**CONTRACT ADDENDUM #**

**date:** 5.10.24  
**project:** Hyde Park Middle School  
**by:** Michael Rigby  
**subject:** Addendum 02

**HPMS ADDENDUM #2**

**SUBJECT:** **Addendum #2 – Changes to Bid Package #1**

**SITE PLAN-NORTHWEST**  
SCALE: 1"=20'

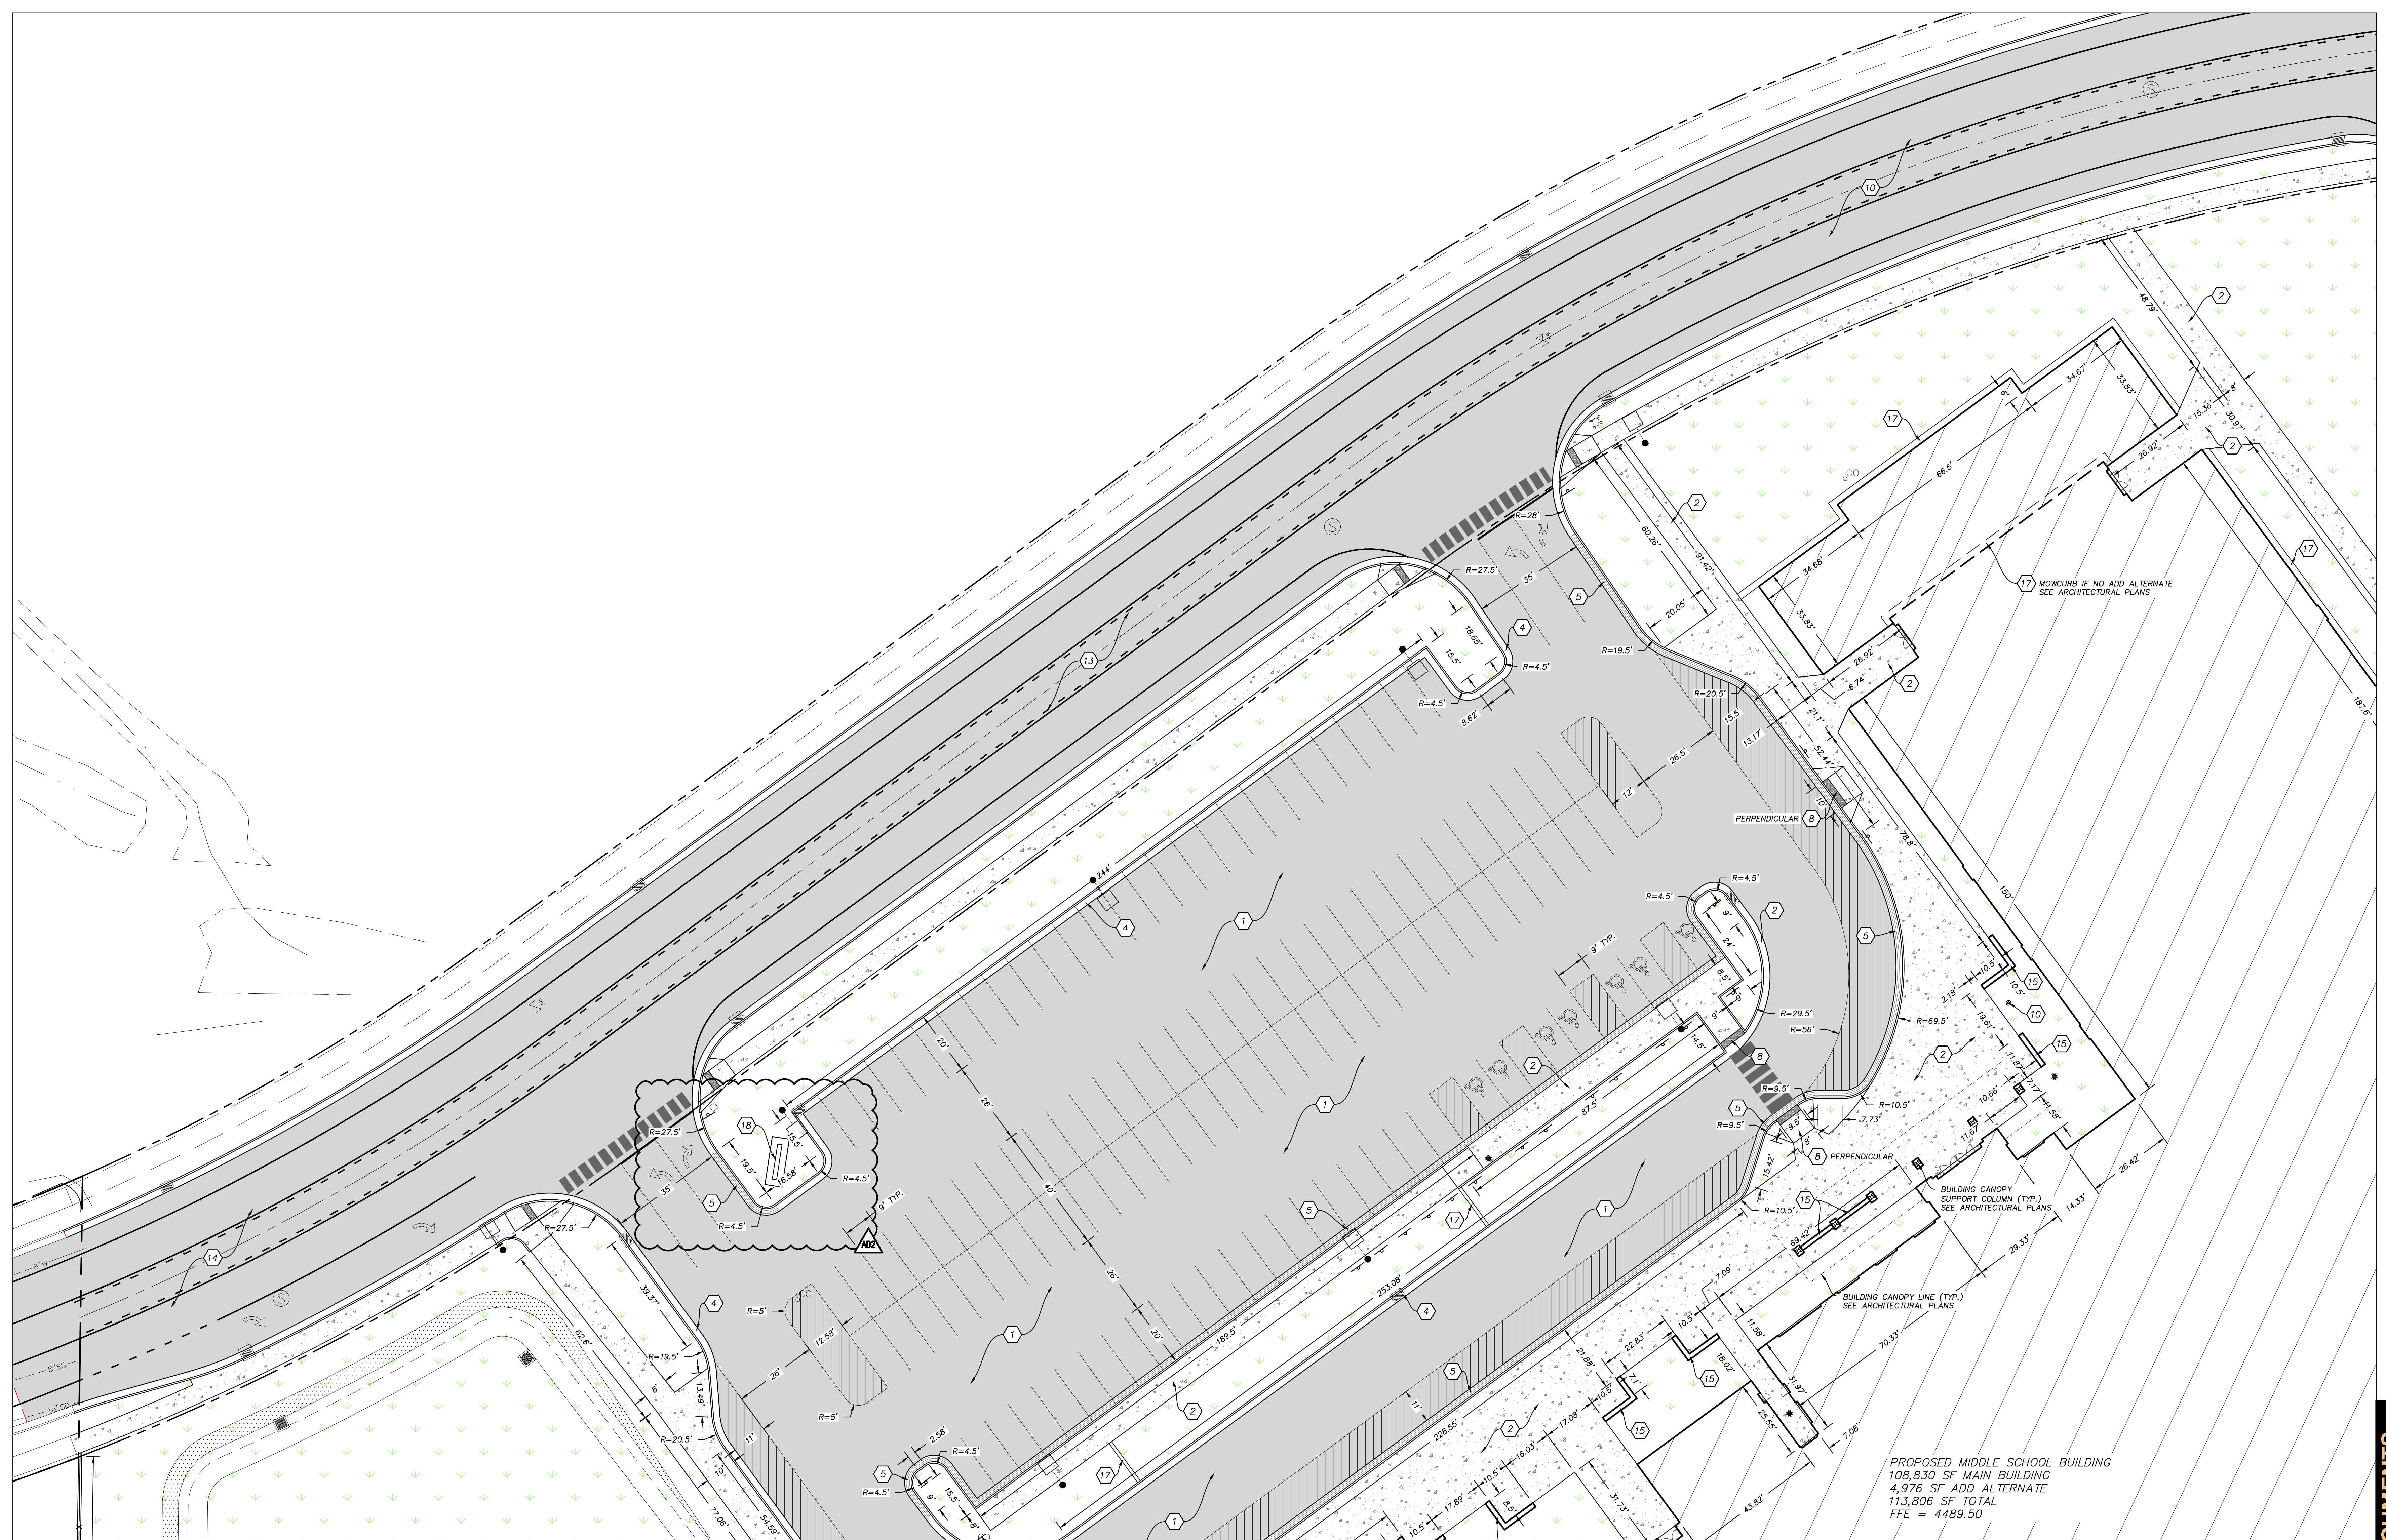
1. **Civil - Site Plan – Northwest, Sheet C-203.**
  - a. **CHANGED** – Monument sign moved from north of building to northeast side of west entrance from 200 South Street.

- b. **CHANGED** – Curbing adjusted to accommodate new monument sign location.
2. **Civil – Utility Plan, Sheet C-301.**
  - a. **REMOVED** – 4” Water meter and connection for landscape irrigation.

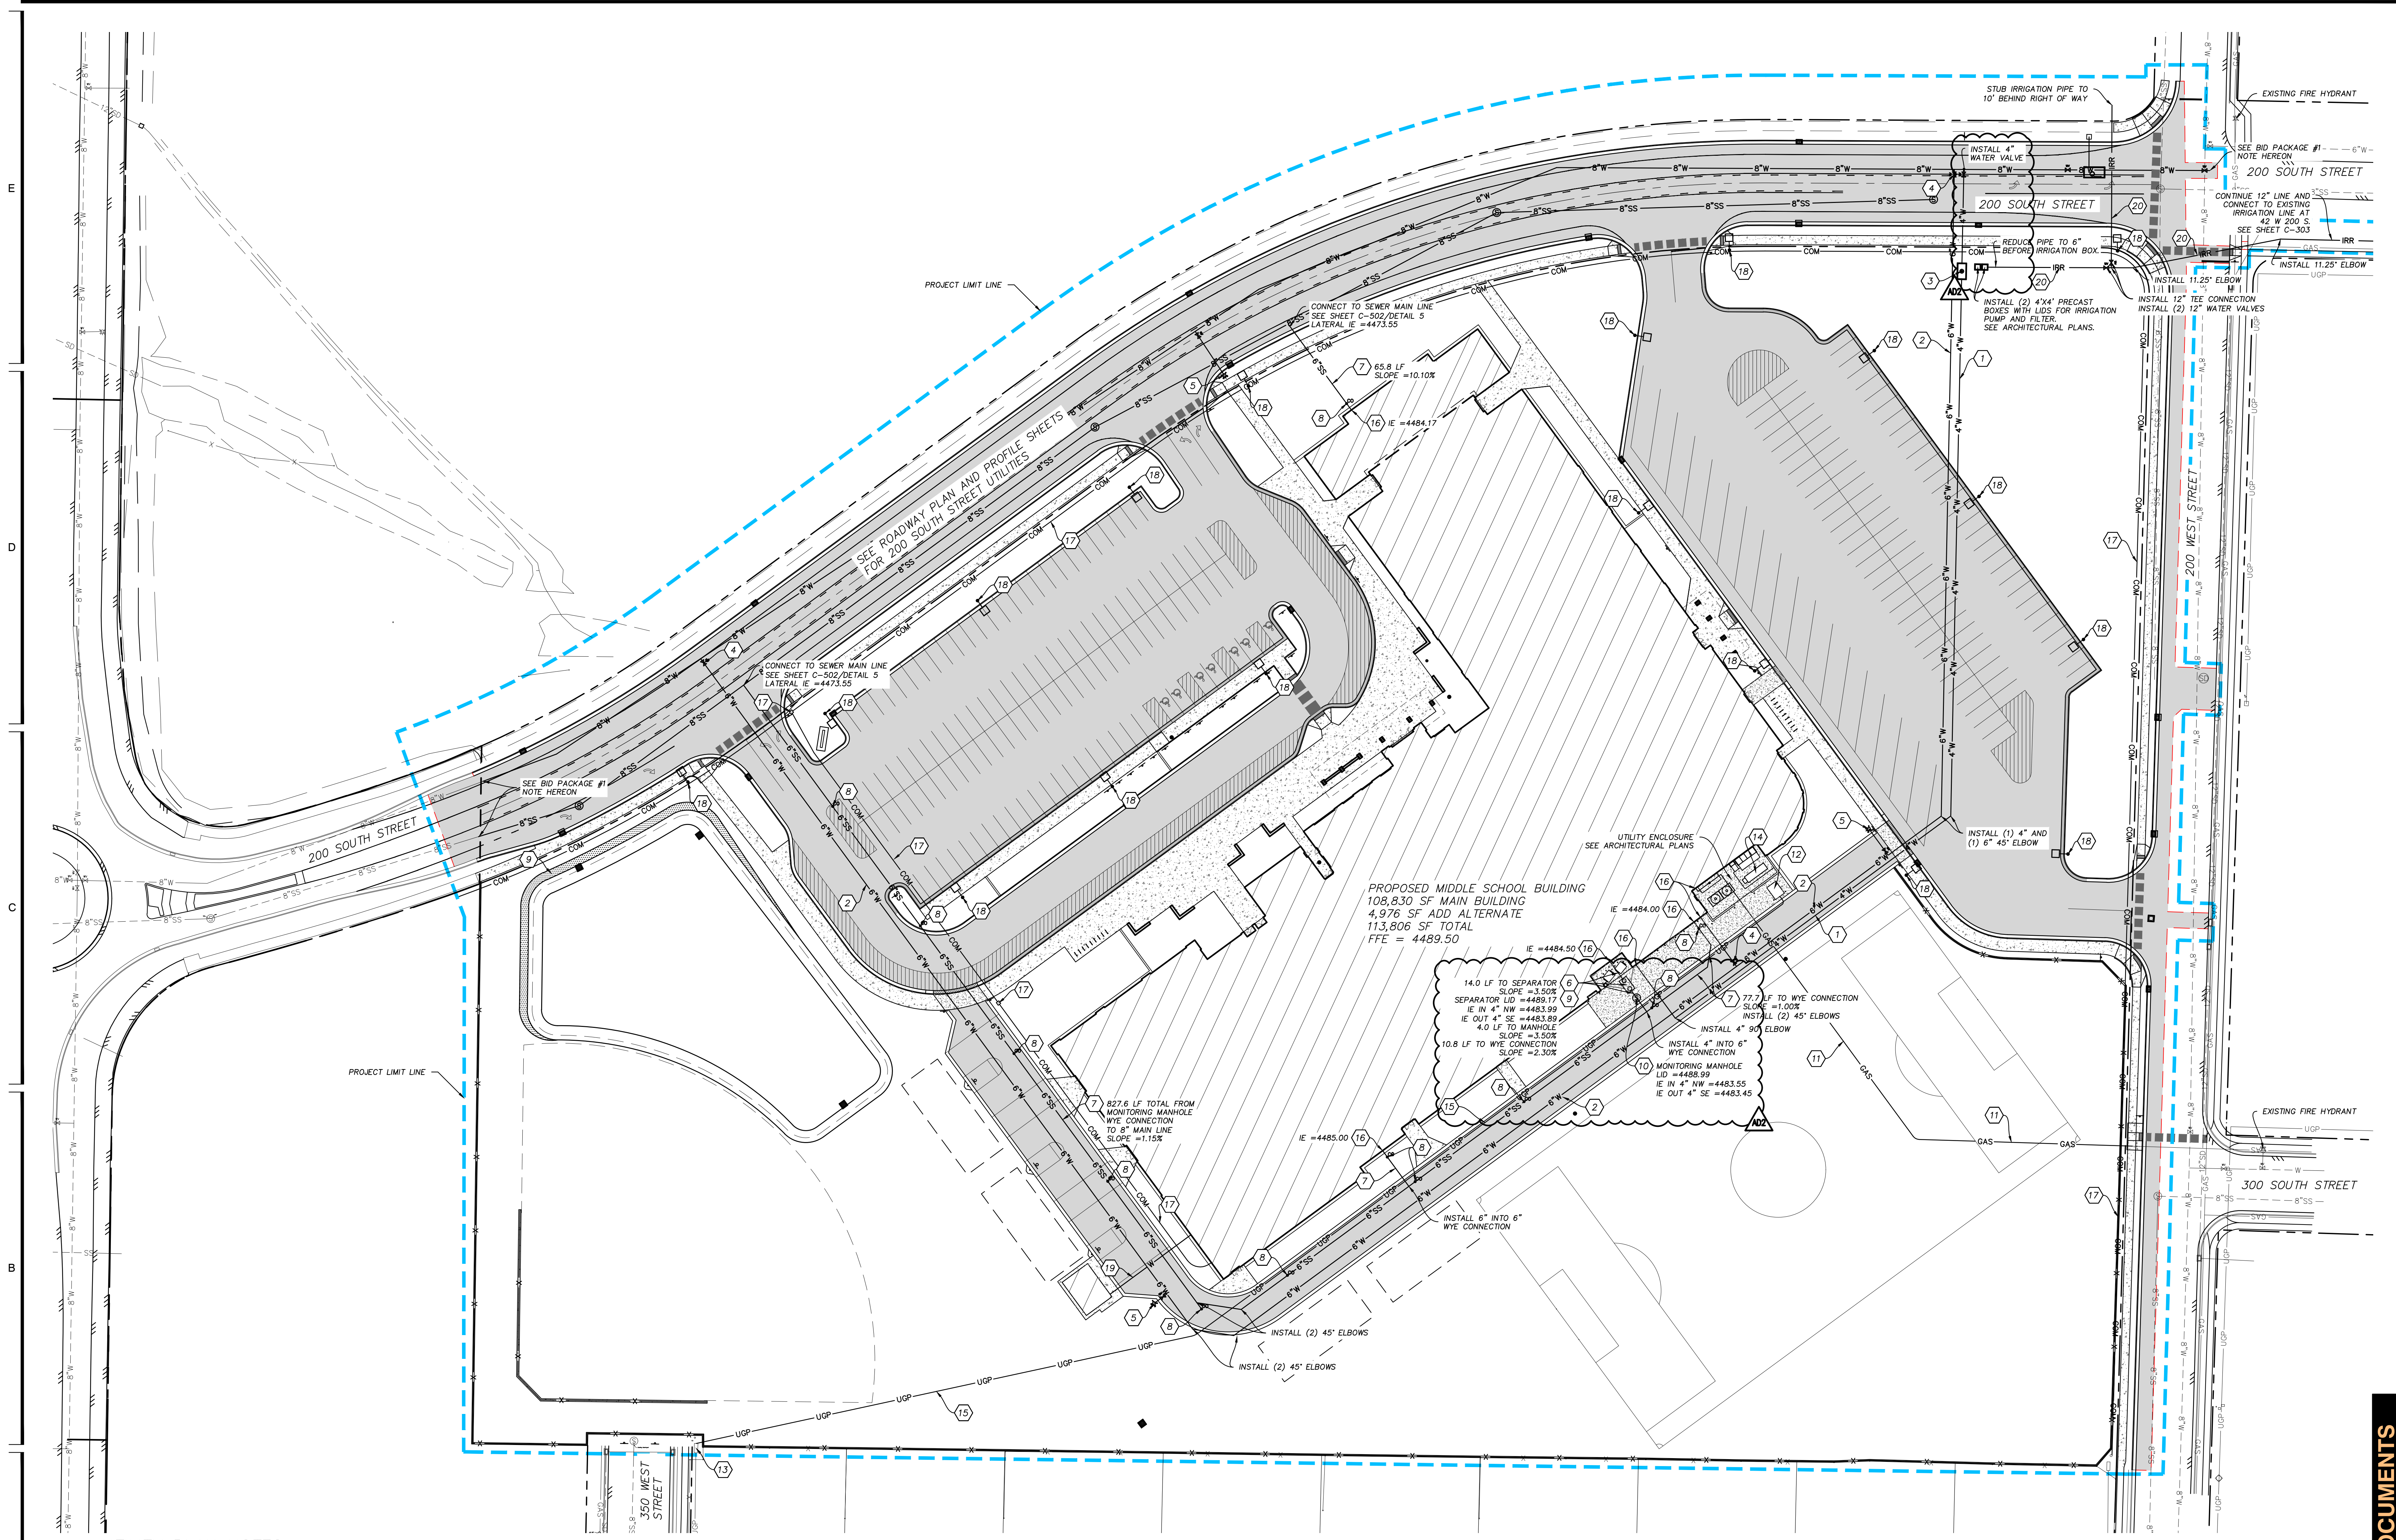
- 7. Civil – Utility Plan, Sheet C-301.**
  - a. ADDED** – 4” valve to culinary water line at the connection with proposed main line in 200 South.
  - b. CHANGED** – Location of monitoring manhole adjusted to prevent contamination from 6” sewer line (human waste).
  - c. CHANGED** – Elevations of grate and pipes for monitoring manhole.
  - d. CHANGED** – Location of grease interceptor adjusted to accommodate change to monitoring manhole.
  - e. ADDED** – 4” into 6” WYE connection at previous monitoring manhole location.
  - f. ADDED** – Sewer line cleanout upstream of WYE connection.

**GRADING PLAN-NORTHWEST**

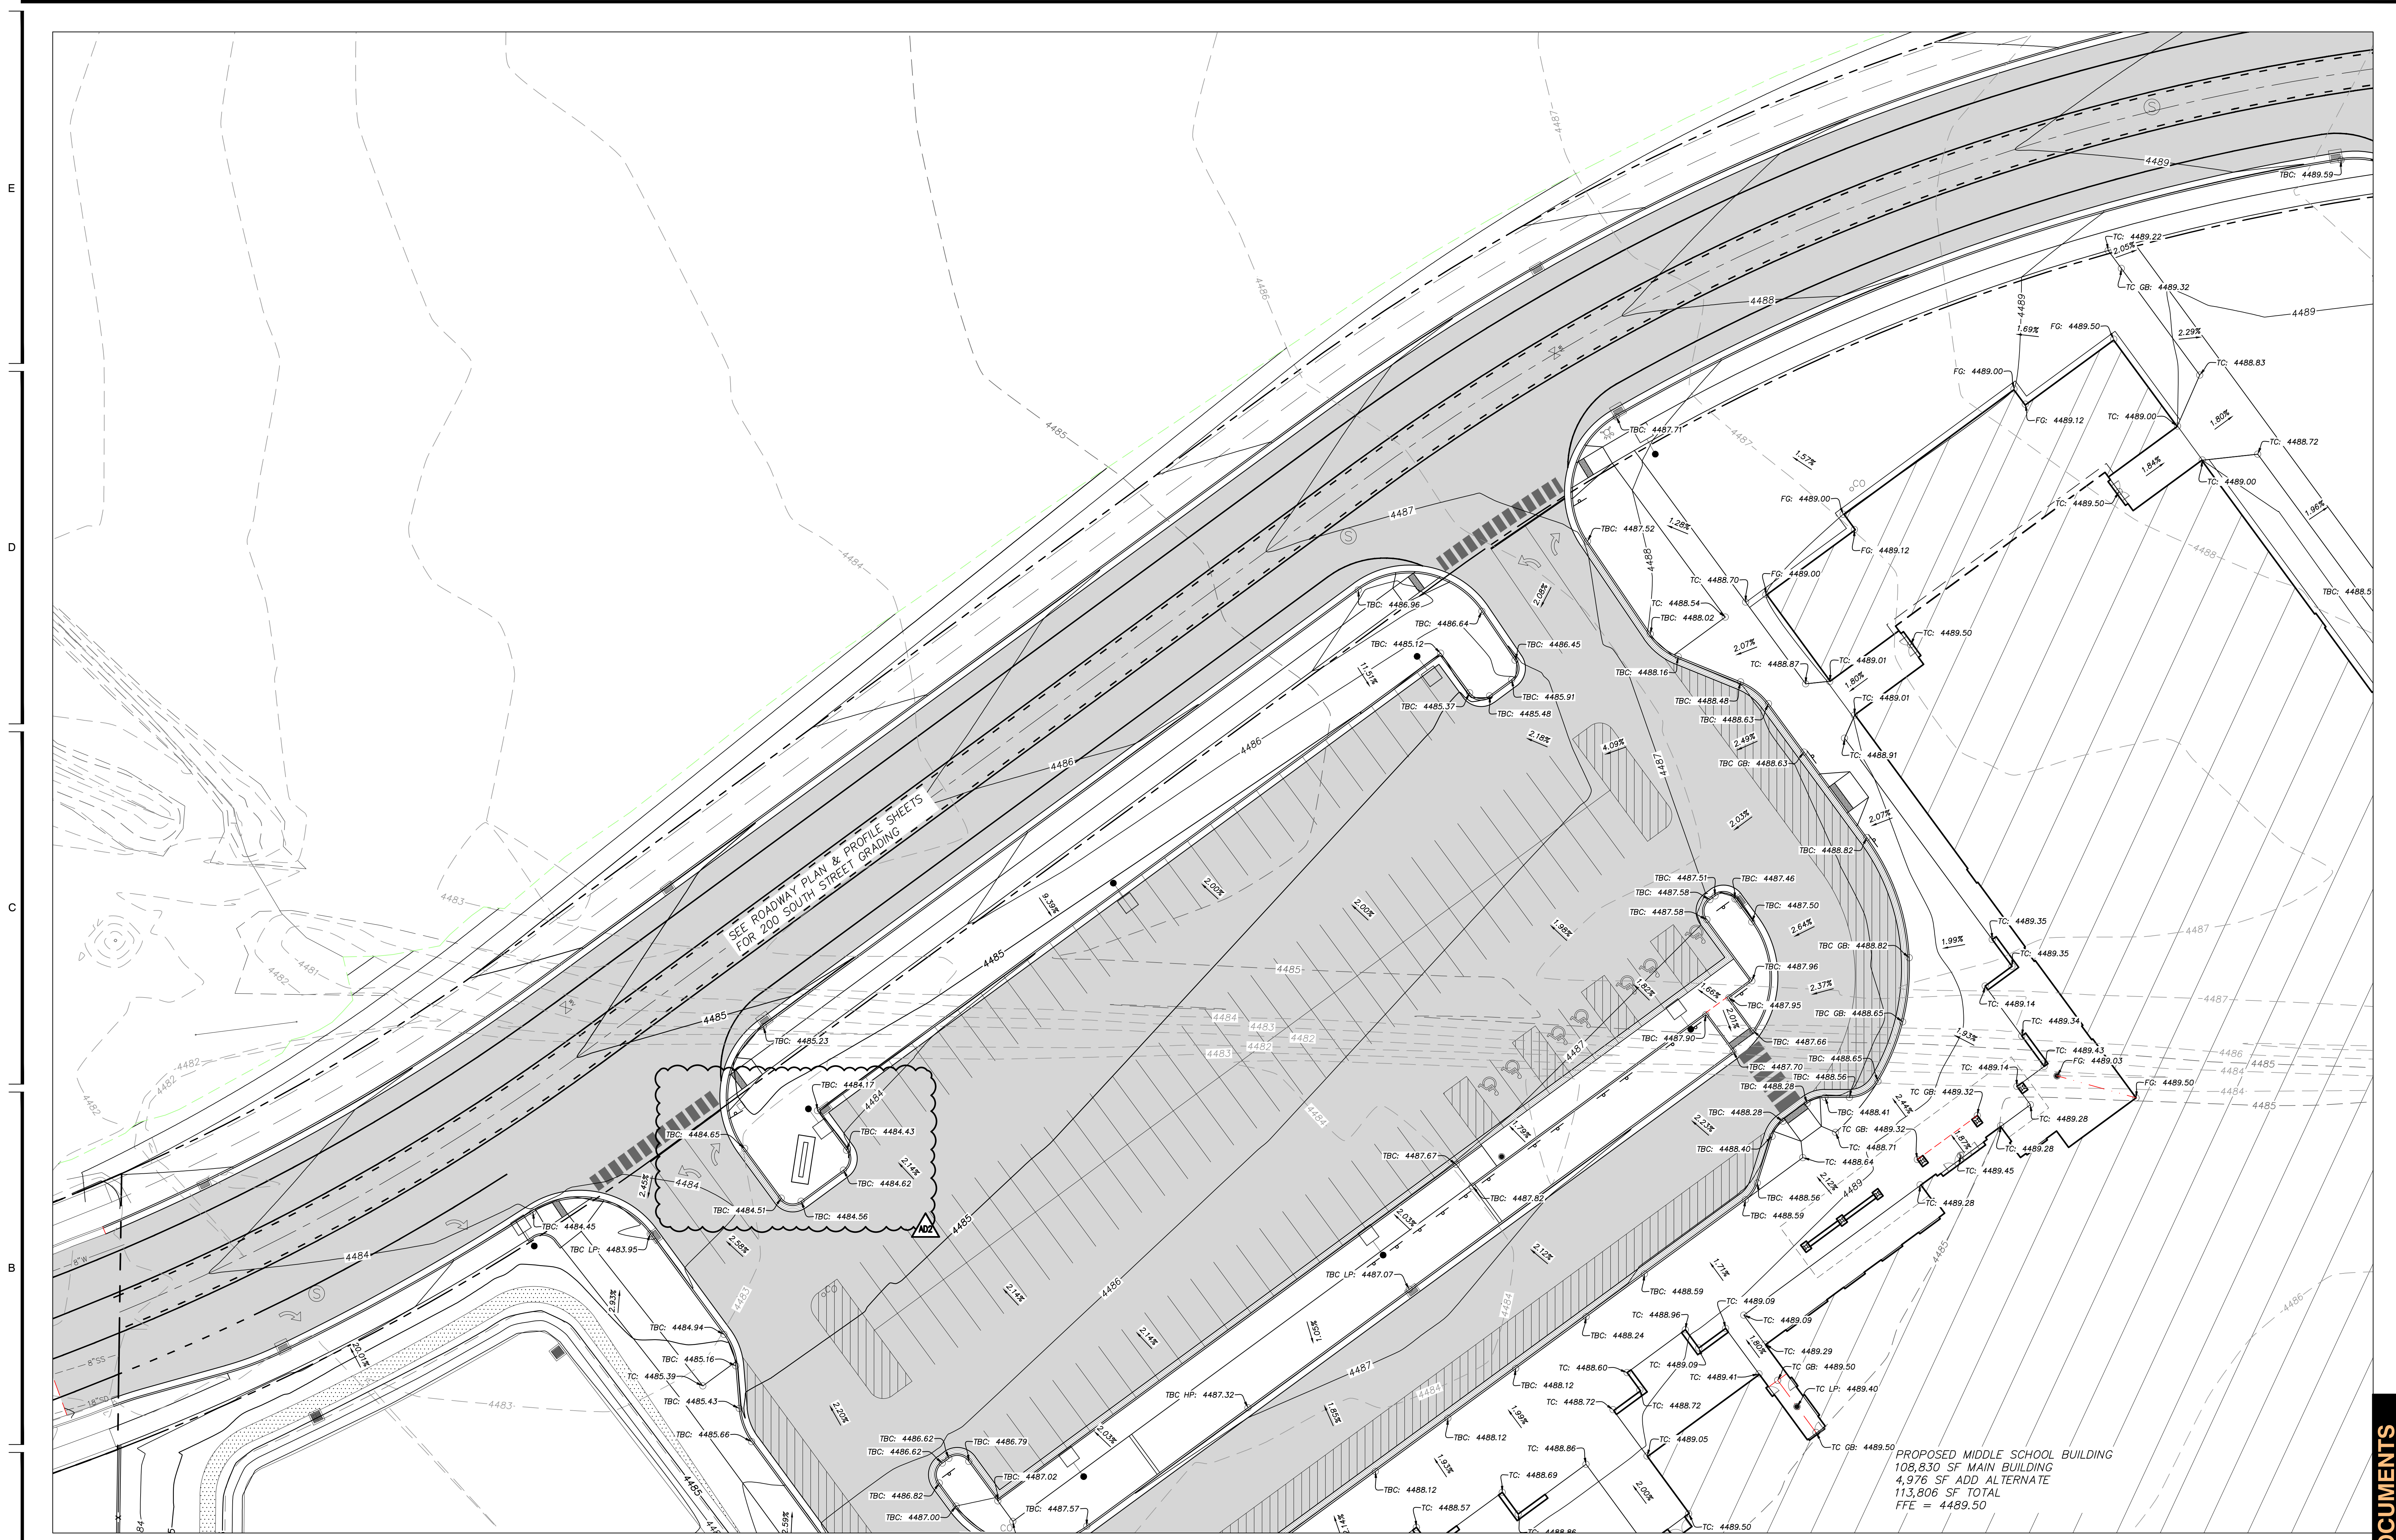
3. **Civil – Grading Plan – Northwest, Sheet C-403.**
  - a. **CHANGED** – Grading for curbing around new monument sign location.
4. **Civil – Utility Details, Sheet C-501.**
